Urban Transportation Plan Amendment

Oso Parkway & Related Streets from FM 43 to CR 20A

Planning Commission Presentation
January 8, 2020

Proposed Amendment

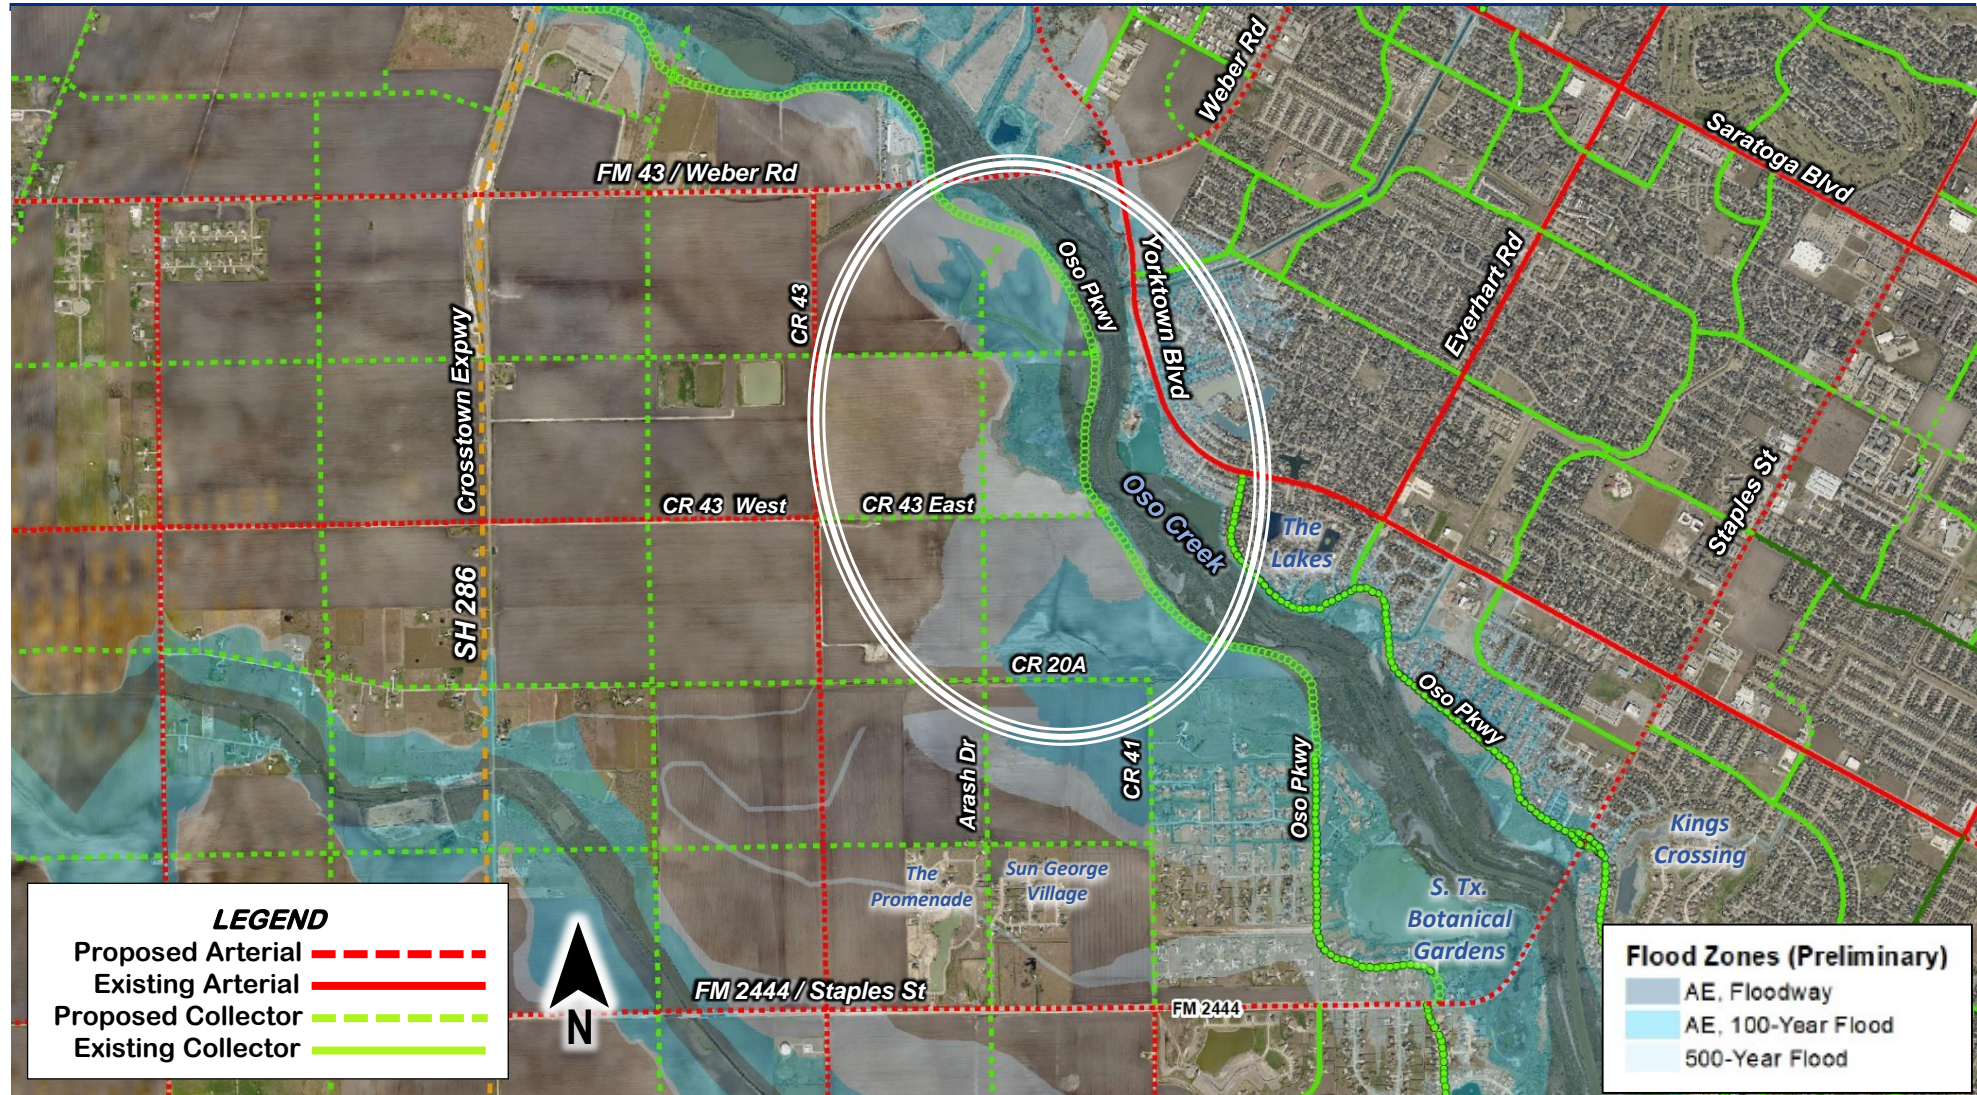
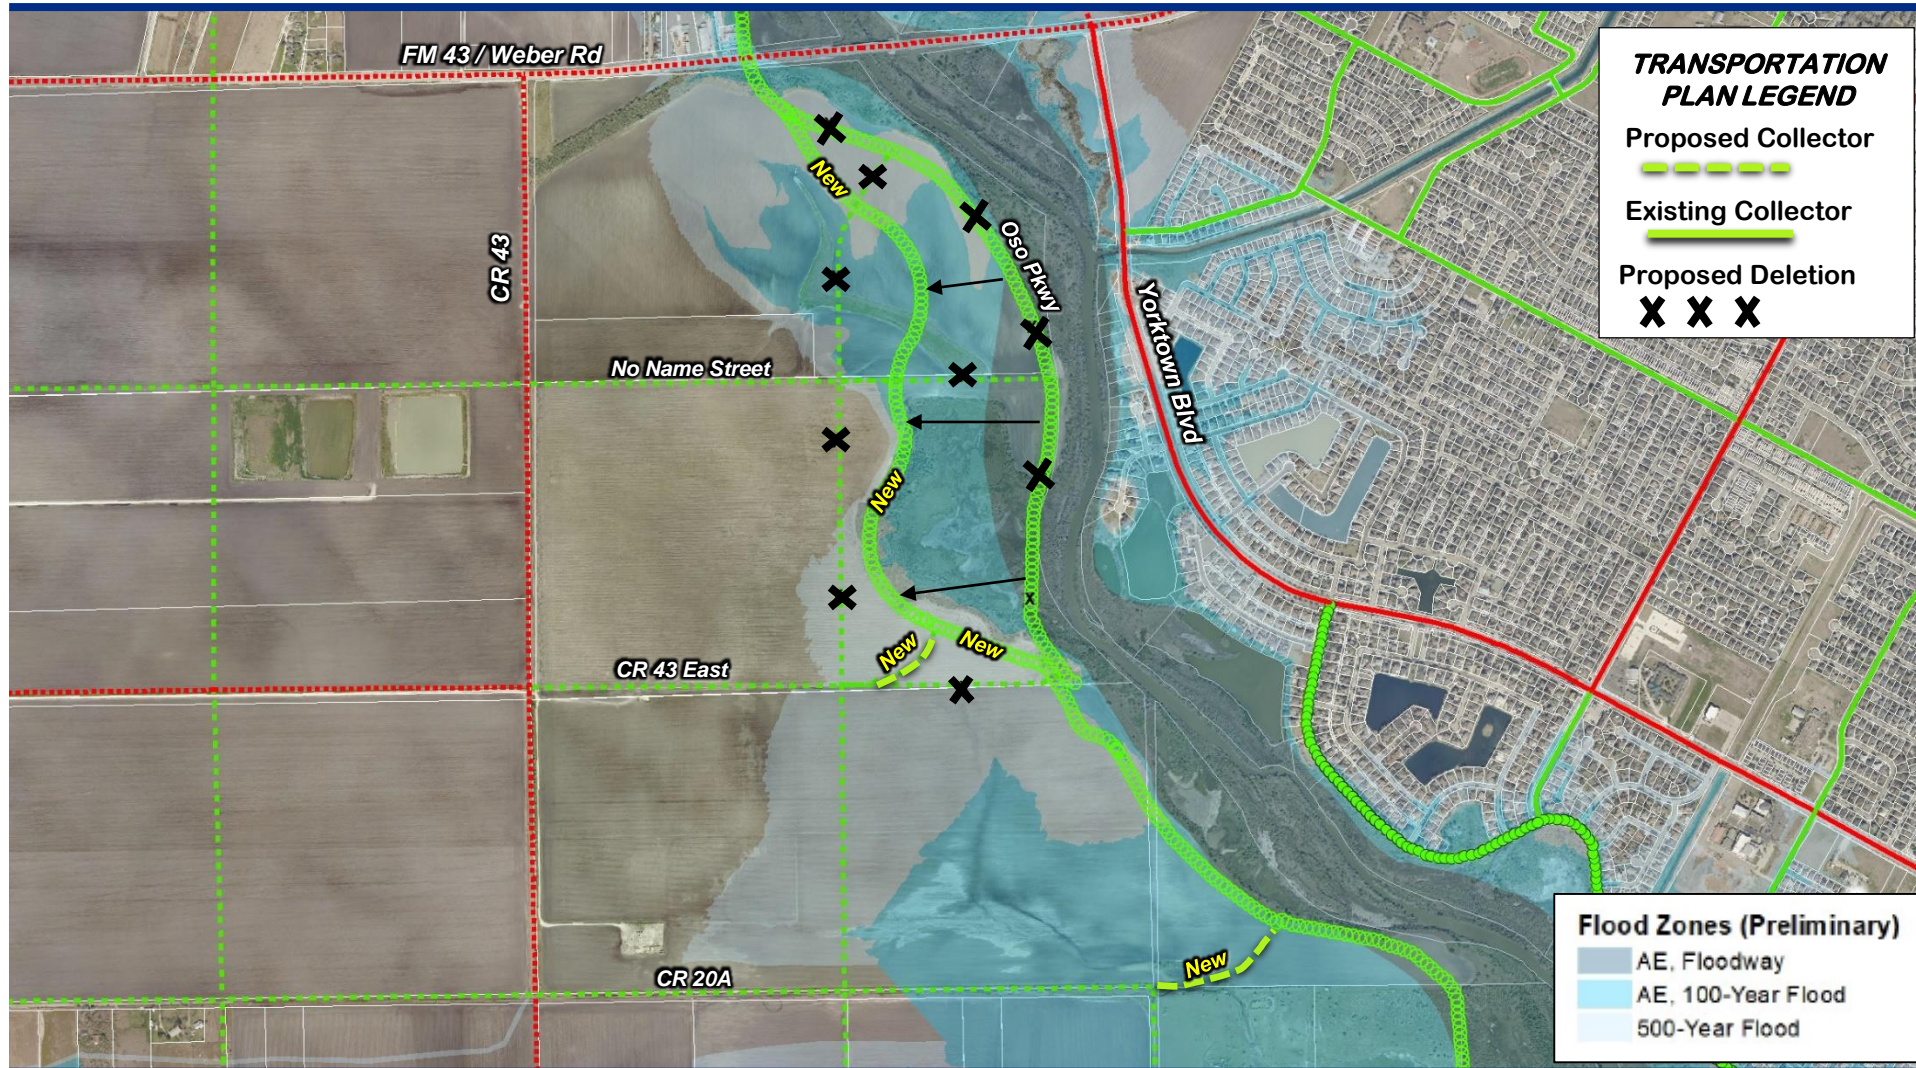
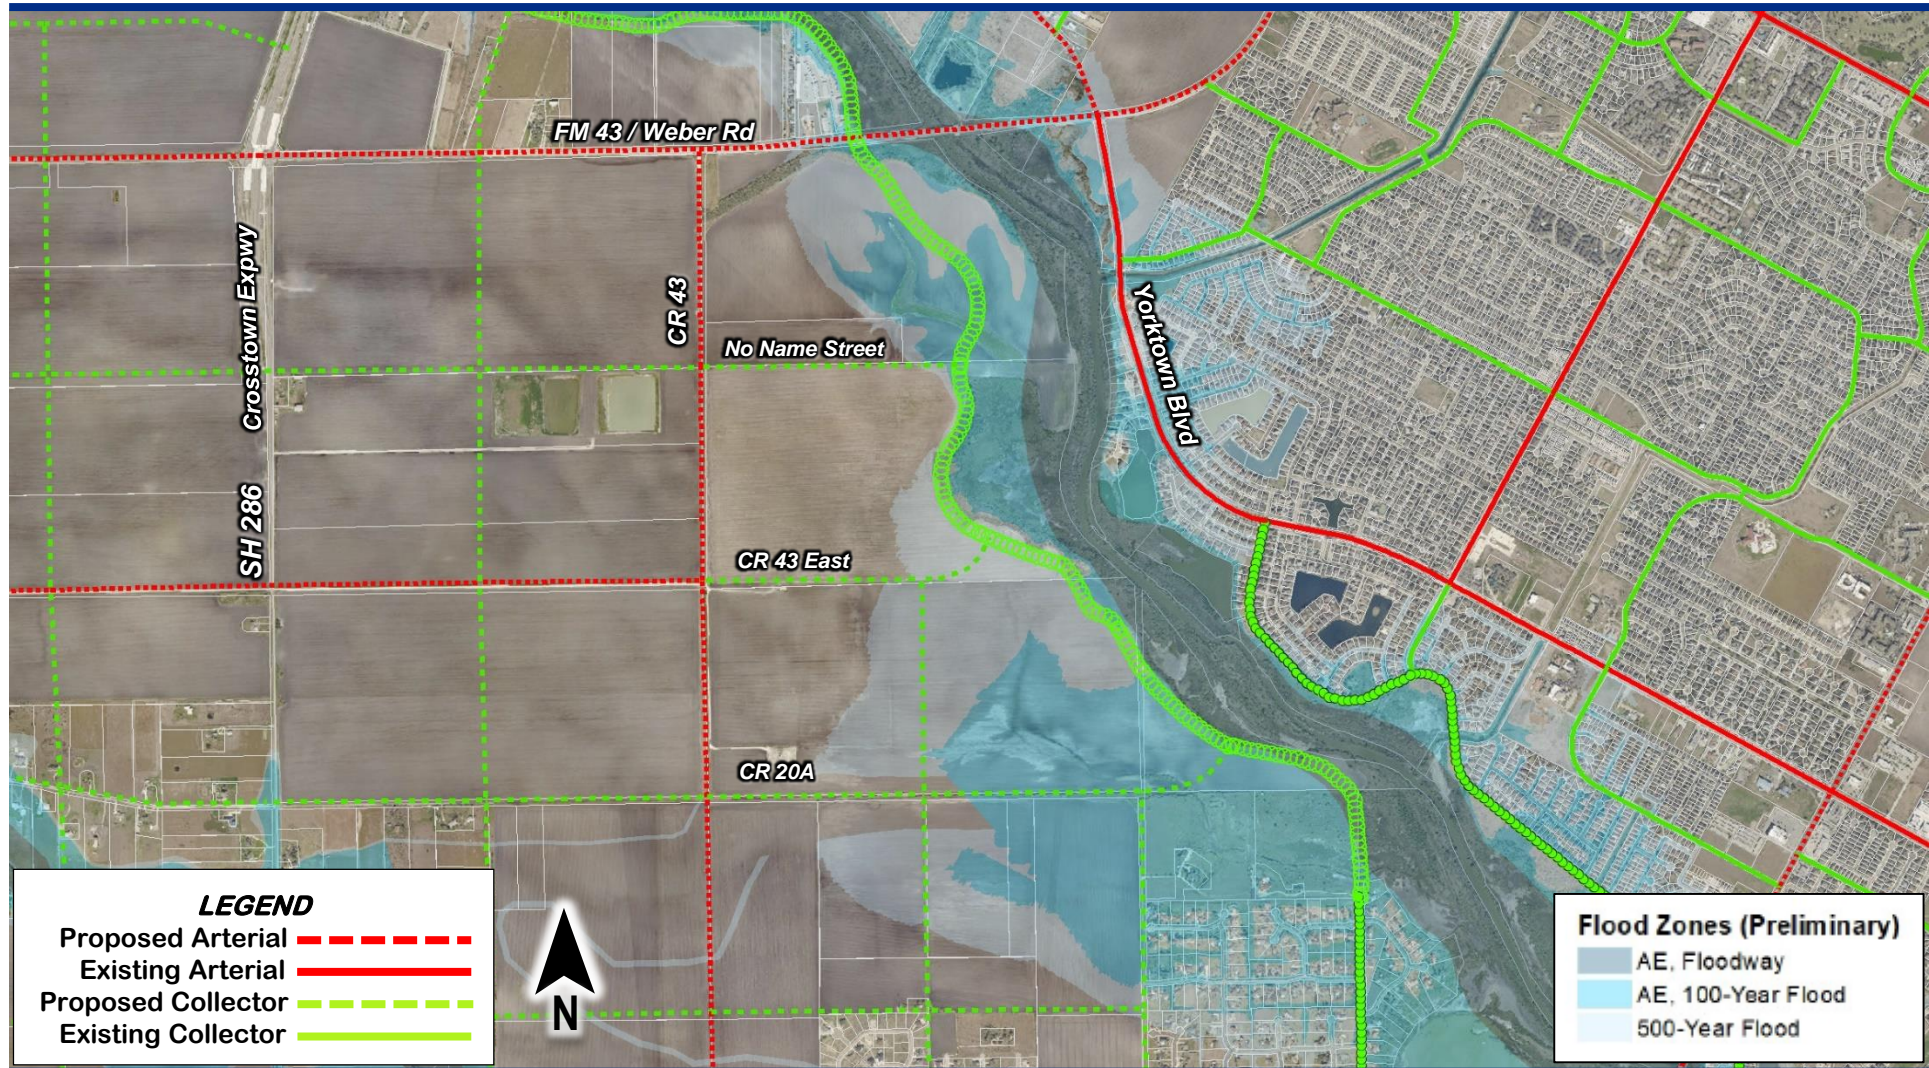
- Realign Oso Parkway out of the 100-year flood zone.
- Delete duplicate north-south Collector.
- Improve alignment of CR 43 East connection with Oso Parkway.
- Connect CR 20A to Oso Parkway to complete network.
